### **IMPACT OF DUBBO QUARRY CONTINUATION PROJECT ON SOUTH KESWICK QUARRY - TRAFFIC IMPACT ASSESSMENT PEER REVIEW**

Table 1-1 Cardno Peer Review

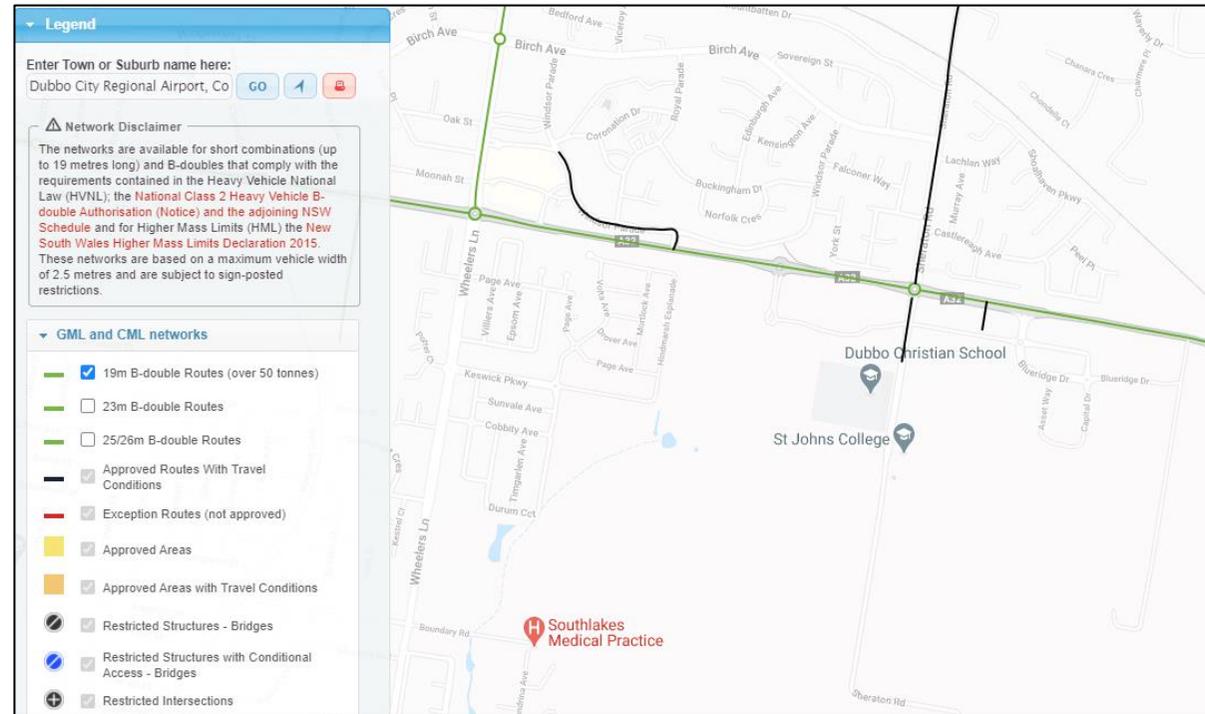
5	Table 4.5 (Item 1)	Children's crossing	The Road Safety Audit correctly highlights an existing issue with the children's crossing located on Sheraton Road. The proposed mitigation of this concern is reliant on the Driver Code of Conduct which is an administrative control rather than a physical measure, however it is considered that further consideration be given to the following:

- Upgrade of the crossing to be in line with current standards and de-risking the outcome; and / or
- Prohibit heavy vehicle movements generated by the Dubbo Quarry to travel along Sheraton Road during school zone hours. This would be consistent with approvals of other quarry's as well as the TfNSW Heavy Vehicle Access restrictions already in place for Sheraton Road.

Figure 1-2 Draft T-intersection at Boundary Road / Sheraton Road

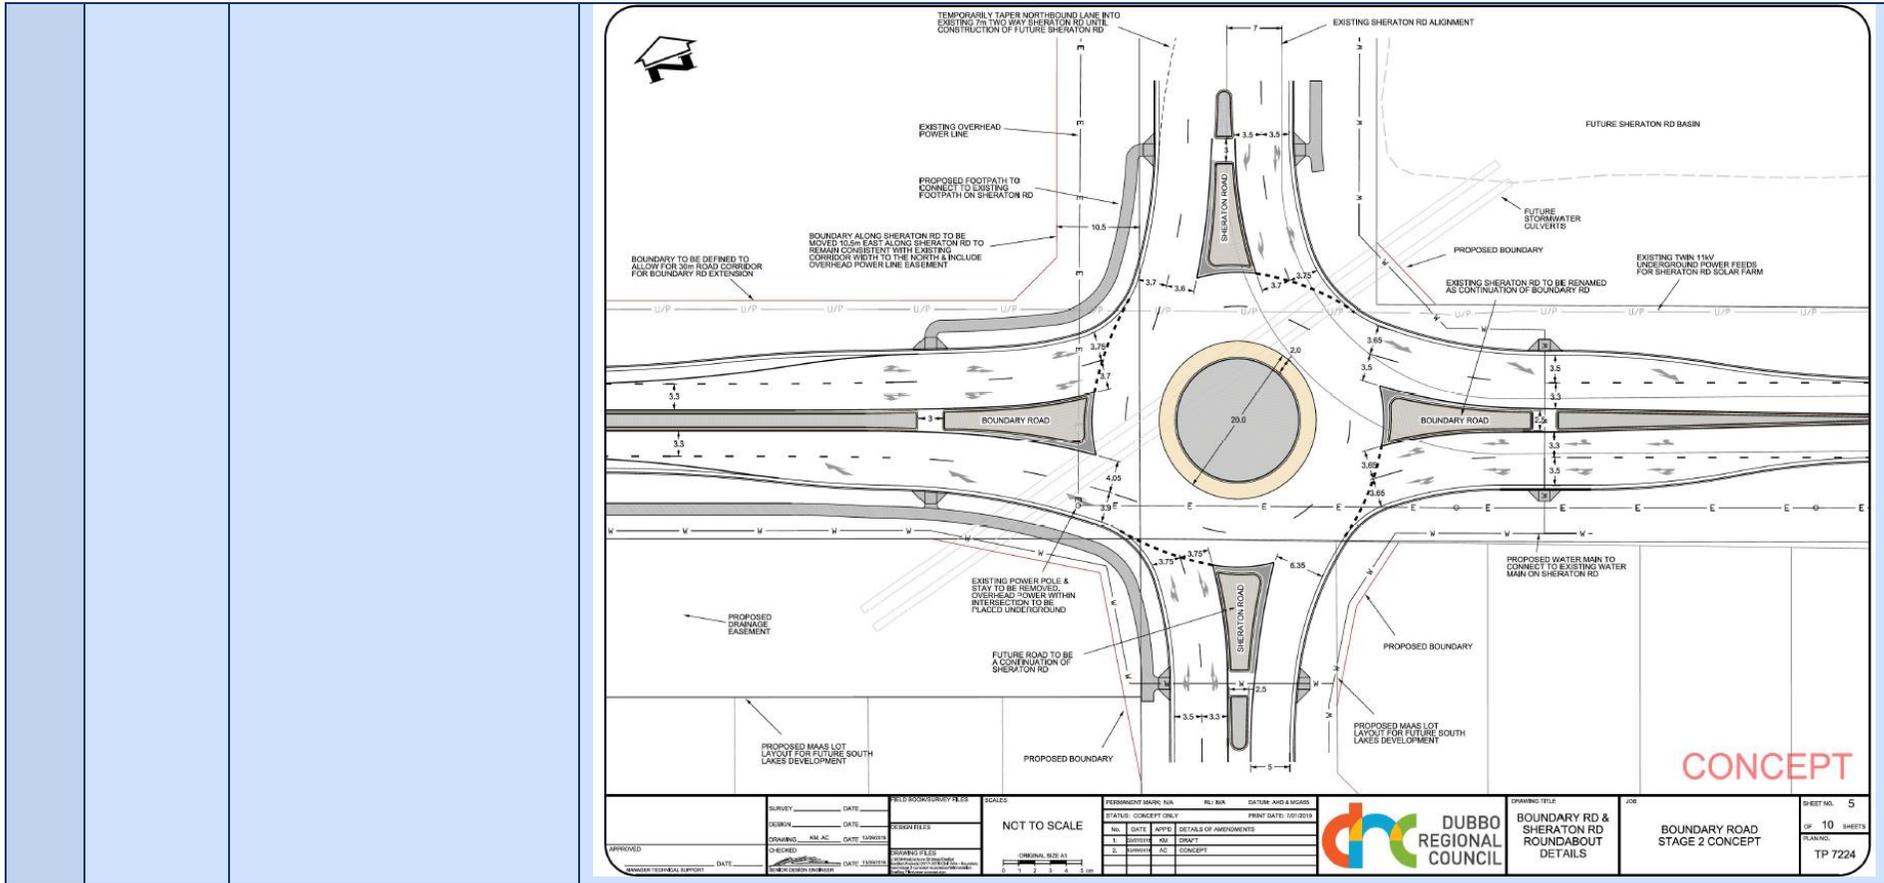
7 Section 4.5 Lack of analysis for Boundary Road / Sheraton Road

Considering the future traffic generation from Southlakes Estate, the South Keswick Quarry and the Dubbo Quarry, the intersection of Boundary Road and Sheraton Road is a key intersection linking these developments which should be modelled and considered.

While a future roundabout at this intersection has been noted, Dubbo Regional Council will be constructing an interim T-intersection with Give Way priority as part of the Boundary Road Extension Project. The intersection will not be a standard T-intersection, with Boundary Road to the west and Sheraton Road to the north forming the priority road. Vehicles from South Keswick Quarry and Dubbo Quarry approaching the intersection from the eastern leg of Sheraton Road will be required to give way to oncoming traffic, and without any intersection modelling, it is unknown whether this will cause any delays, queuing or impact on Level of Service.
